**CHARLOTTE - MECKLENBURG**  
**PLANNING COMMISSION**

**SUBJECT:** Administrative Approval for Petition No. 98-42(c) by Erwin Capital, Inc. and The Crosland Group, Inc.

# ERWIN CAPITAL/BEAVER FARMS SKETCH PLAN

**SUBJECT:** Administrative Approval for Petition No. 1998-042C Erwin Capital and The  
Crosland Group

SHEET NO. 2 OF 2  
FILE NAME: 18021/18021B06.DWG

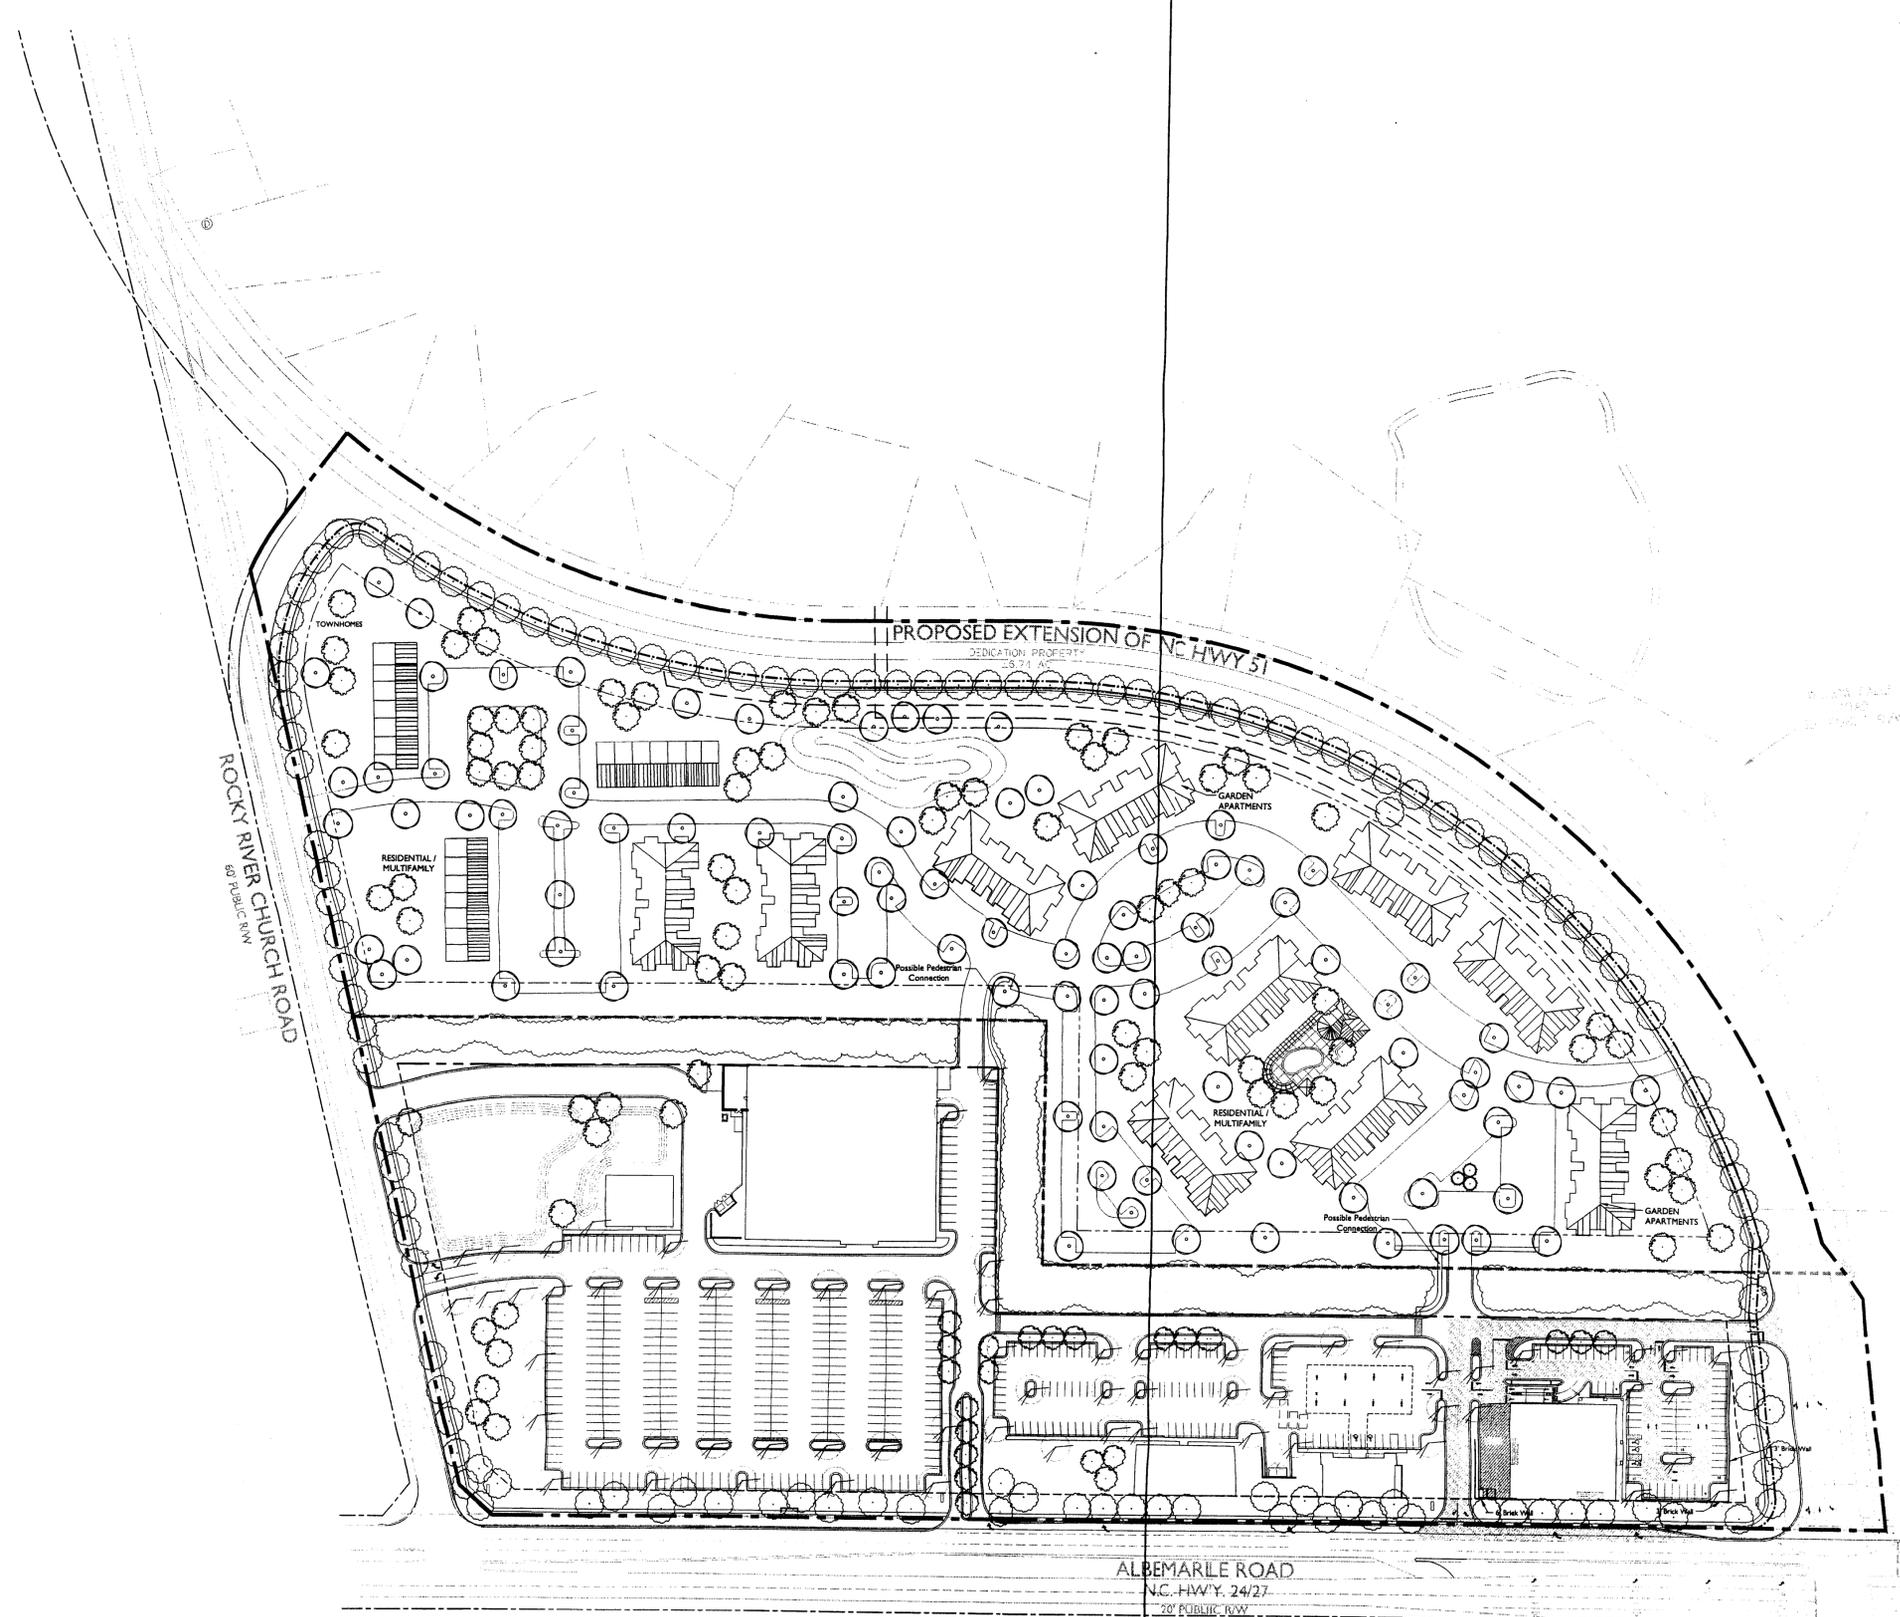
Attached is a revised sketch plan sheet 2 and elevations for the drug store. Since this plan reflects minor changes to the site layout and does not alter the intent of the original site plan, I am administratively approving this revised plan and elevations. Please use this revised plan and elevations when evaluating requests for building permits and certificates of occupancy.

**Note that sheet 1 and elevations for the grocery store from the original approval still apply.**  
**All other ordinance requirements still apply.**

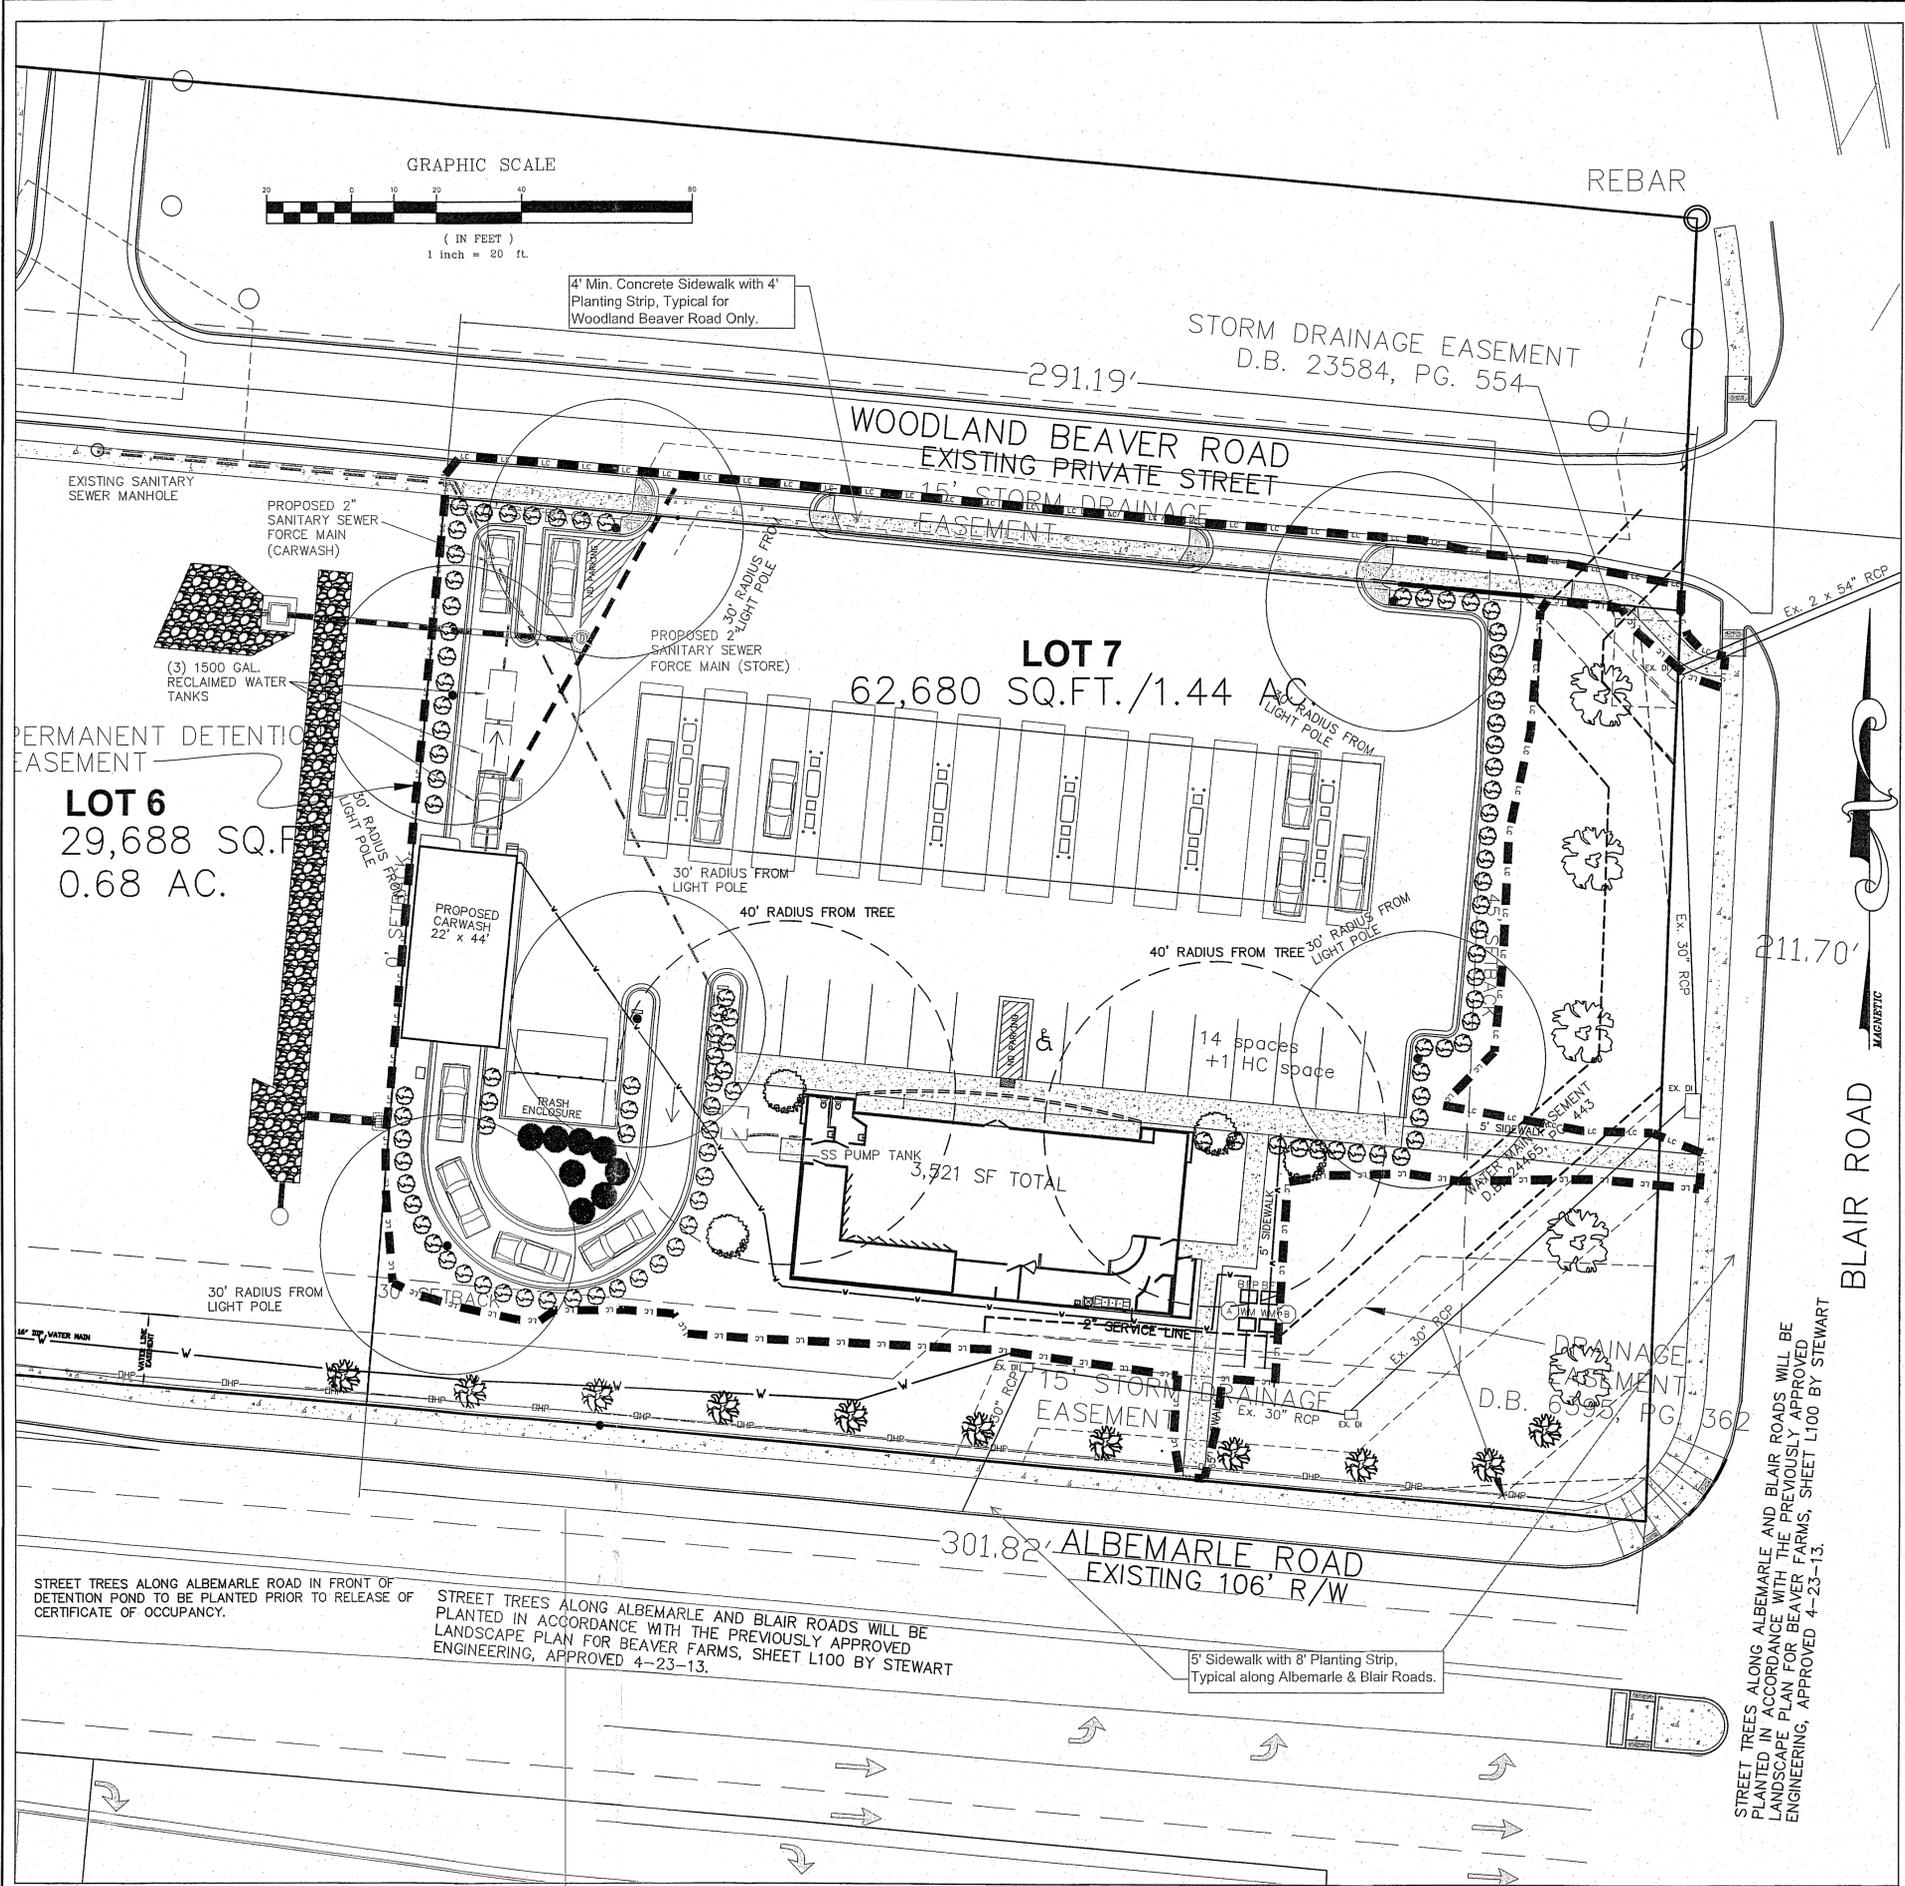
Attached is the revised site plan for the petition above. This request allows the modification of the proposed site plan as listed below. Since these changes do not alter the intent of the development and meets the requirements of the Charlotte Zoning Ordinance Section 6.207 Alterations to Approval, minor changes, I am administratively approving this plan. Please use these plans when evaluating requests for building permits and certificates of occupancy.

- Proposed building elevations for the proposed convenience store with accessory pumps.
